SOUTHERN ENVIRONMENTAL LAW CENTER

> Re: Final Ash Impoundment Closure Environmental Impact Statement, Part I -Programmatic NEPA Review, and Part II, Site-Specific NEPA Review (June 2016)

The undersigned groups are writing to provide comments on the Final Ash Impoundment Closure Environmental Impact Statement (Part I-Programmatic NEPA Review and Part II-Site-Specific NEPA Review) ("FEIS").

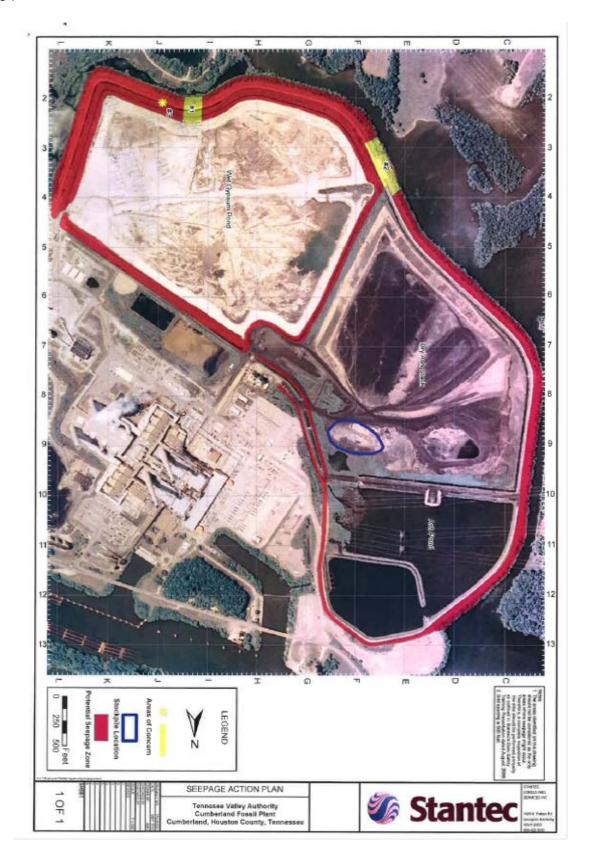
TVA's ponds that the state requires TVA to monitor and report seeps on a quarterly basis. TVA itself has acknowledged the pervasive nature of seeps at its impoundments. For example, the following figure from TVA's "2015 Seepage Action Plan" at Cumberland Fossil Plant identifies the *entire perimeter* of the ash impoundments as the "potential seepage zone":

Despite the pervasive nature of seeps at its impoundments, TVA's perfunctory response fails to explain how closing its ash ponds in place will address existing and potential future seeps. This is particularly concerning in light of TVA's admission that the ash in many of its ponds is buried in groundwater and its failure to demonstrate that that the ash will be removed from the groundwater prior to closure. TVA says nothing about attempting to stop the flow of contaminated groundwater into and through impoundments when repairing seeps.
